Documentation of Public Meeting

State Loop 360 at Lakewood Drive/Spicewood Springs Road 0113-13-169 and 0113-13-167

From north of RM 2222 to Winding Ridge Boulevard and From Winding Ridge Boulevard to south of Great Hills Trail

June 6, 2019 at 4 to 6 p.m.

BENT CAP Standard RectangularCOLUMNS Round

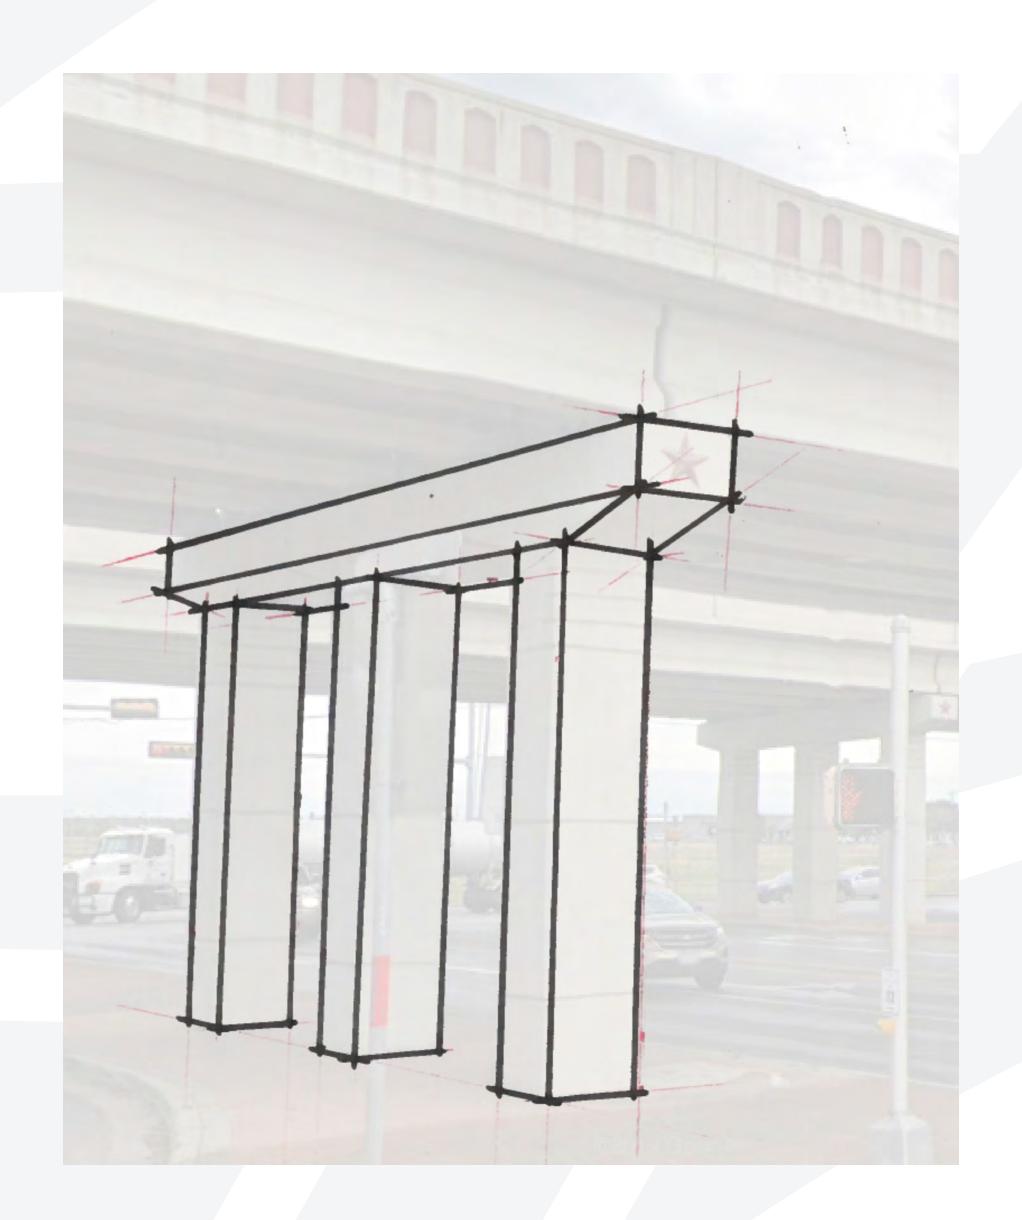
the design for this intersection by minimizing the impact to the neighborhood instead of planning for a non-existent potential for growth.	
29.	Clardy, Mark	06/19/2019	Online Comment	CSS Options for Bridge Supports - I prefer the bent cap SLOPED with ROUND columns	Comment noted.
